ENGINE - H.P. COMPRESSOR BLADES - STAGES 9 TO 12 ROTOR BLADES WITH PLATFORM CORNER
CROPPED - CATEGORY CODE 6 - MOD.ENG-72-0172

V2500-ENG-72-0172

SERVICE BULLETIN

Reworking of existing H.P. compressor stages 10 and 11 L.H. locking blades (A1 Model)
Fig.2

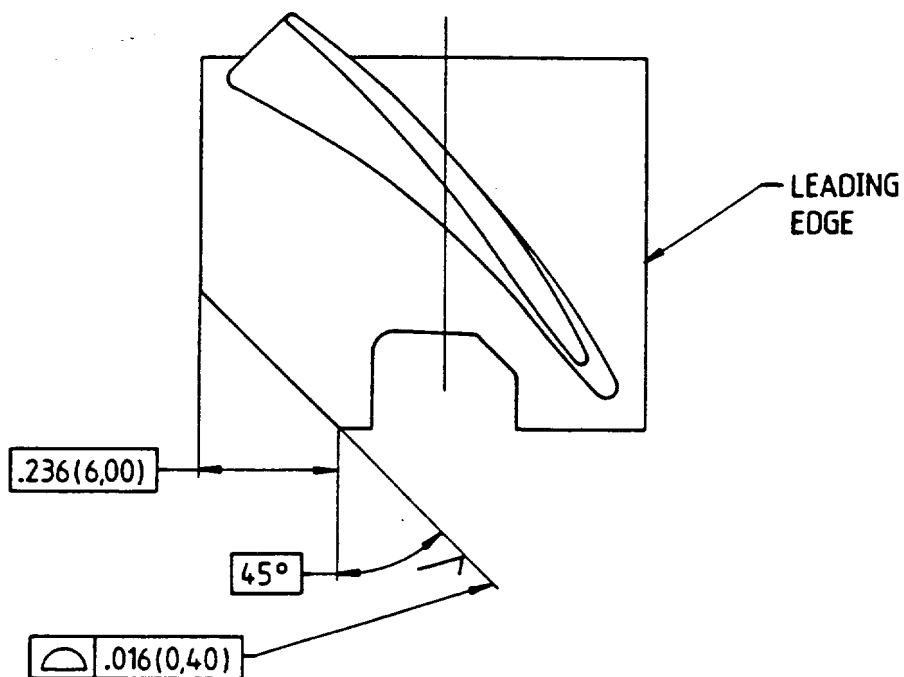
The stage 10 to 12 L.H. locking blades have the platform corner cropped at the rear side.

- (d) Grind back the rotor blade platform, where shown

See Figures 2, 5 and 7, as necessary

See Figures 2, 5 and 7.
Use standard workshop equipment.

See Figures 2, 5 and 7, as necessary

Reworking of existing H.P. compressor stage 9 R.H. locking blades (A1 Model)
Fig.4

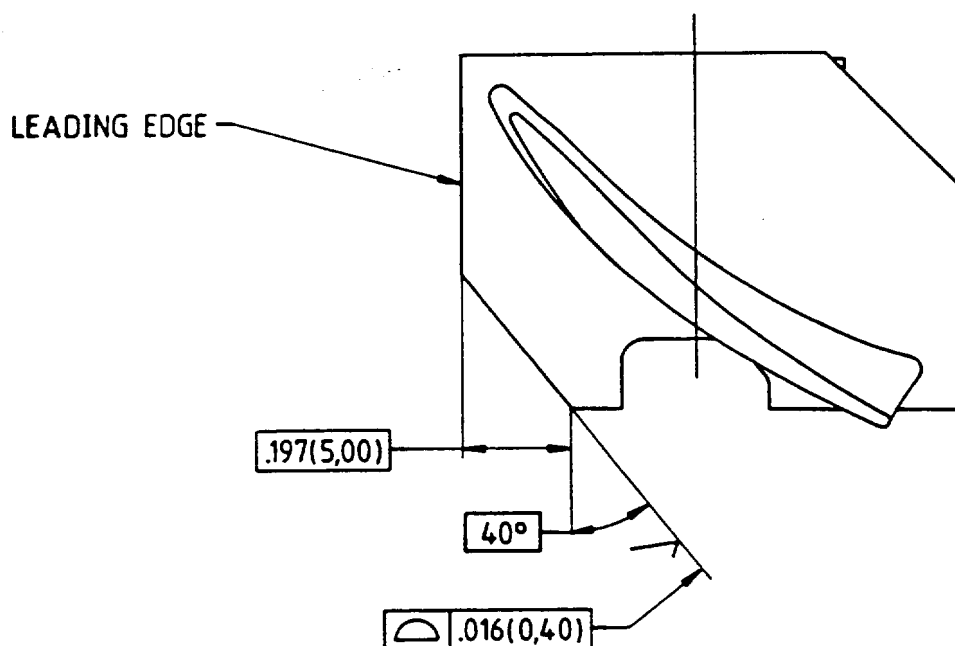
The stage 9 R.H. locking blades have the platform corner cropped at the front side. the cropping of the rear side platform corner applied by S.B. V2500-ENG-72-0109 is retained.

6A4367, blade, locking, R.H. - Compressor, H.P. - Stage 9 (Refer to 72-41-15, Fig./Item 02-485) and
 6A846, blade, locking, R.H. - Compressor, H.P. - Stage 9 (Refer to 72-41-15, Fig./Item 02-485).

Procedure	Supplementary Information
(a) Install the fixture on to the machine	Use IAE 3R19085 grinding fixture (A1 engine), 1 off, or IAE 3R19086 grinding fixture (A5/D5 engine), 1 off, as necessary, with a grinding machine
(b) Set the height of the grinding fixture	Use a 0.100 in. (2,54 mm) slip
(c) Install the rotor blade into the grinding fixture	Make sure the rotor blade is located correctly
CAUTION: CARE MUST BE TAKEN TO ENSURE THAT NO WITNESS OF THE PLATFORM MACHINING APPEARS ON THE ROTOR BLADE DOVETAIL.	
(d) Grind back the rotor blade platform, where shown	See Figures 4, 5 and 7, as necessary
(e) Remove sharp edges	See Figures 4, 5 and 7. Use standard workshop equipment.
(f) Measure the dimensions	See Figures 4, 5 and 7, as necessary

Reworking of existing H.P. compressor stage 10 and 11 R.H. locking blades (A1 Model)
and stages 9, 10 and 11 R.H. locking blades (A5 and D5 Models)

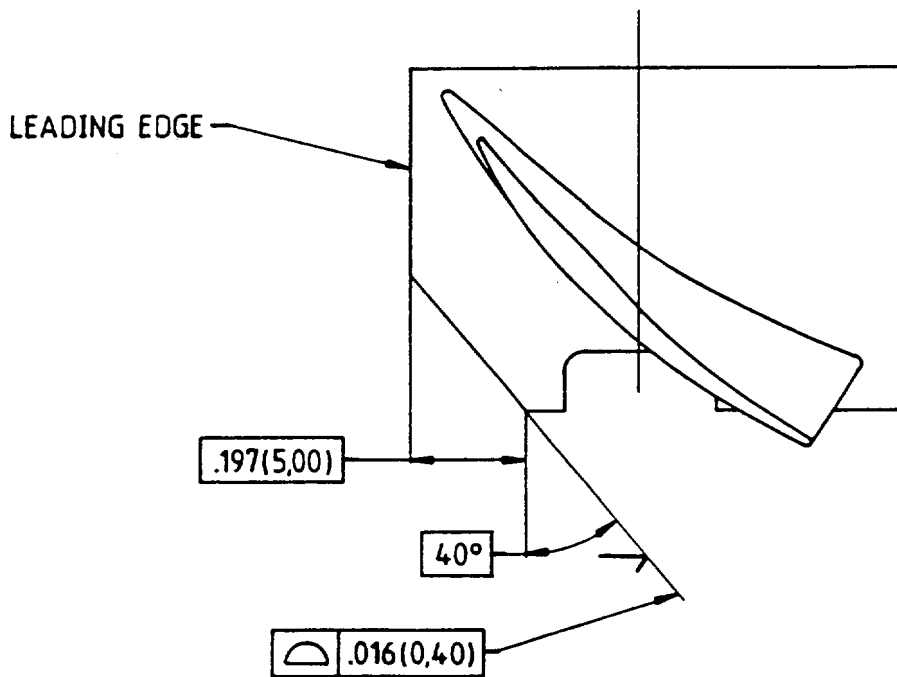
The stage 10 to 12 R.H. locking blades have the platform corner cropped at the front side.

The stage 9 to 12 R.H. locking blades have the platform corner cropped at the front side.

Reworking of existing stage 9 rotor blades
Fig.8

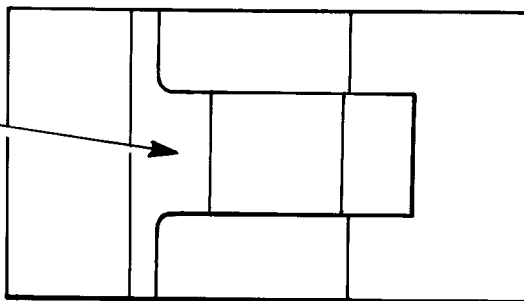
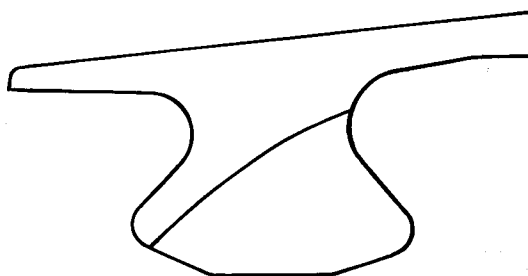
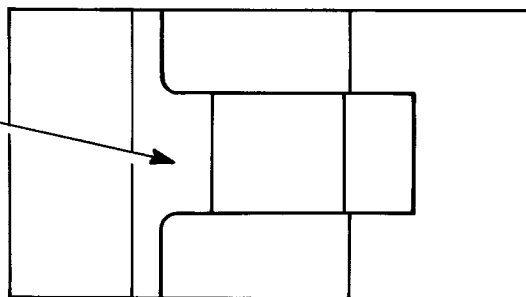
- (ii) This procedure is alternative to step (g)(i). It is permissible to re-identify the blade by adding the symbol as shown in Figure 8. Do not delete the existing part number if you use this procedure.

- a) IF ALTERNATIVE METHOD OF BLADE IDENTIFICATION IS CHOSEN, ENGRAVE THE SYMBOL  HERE
- b) IF SYMBOL  IS PRESENT, THE BLADE HAS PREVIOUSLY BEEN REWORKED TO SBE 72-0109 STANDARD. USE EXISTING SYMBOL  AND ENGRAVE THUS:

Reworking of existing stage 10, 11 and 12 rotor blades
Fig.9

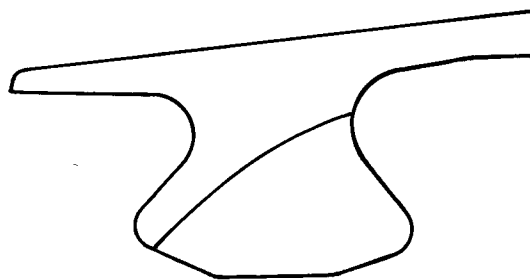
- (ii) This procedure is alternative to step (g)(i). It is permissible to re-identify the blade by adding the symbol as shown in Figure 9. Do not delete the existing part number if you use this procedure.

- (ii) This procedure is alternative to step (g)(i). It is permissible to re-identify the blade by adding the symbol as shown in Figure 9. Do not delete the existing part number if you use this procedure.

IF ALTERNATIVE METHOD
OF BLADE IDENTIFICATION
IS CHOSEN, ENGRAVE
THE SYMBOL  HERE
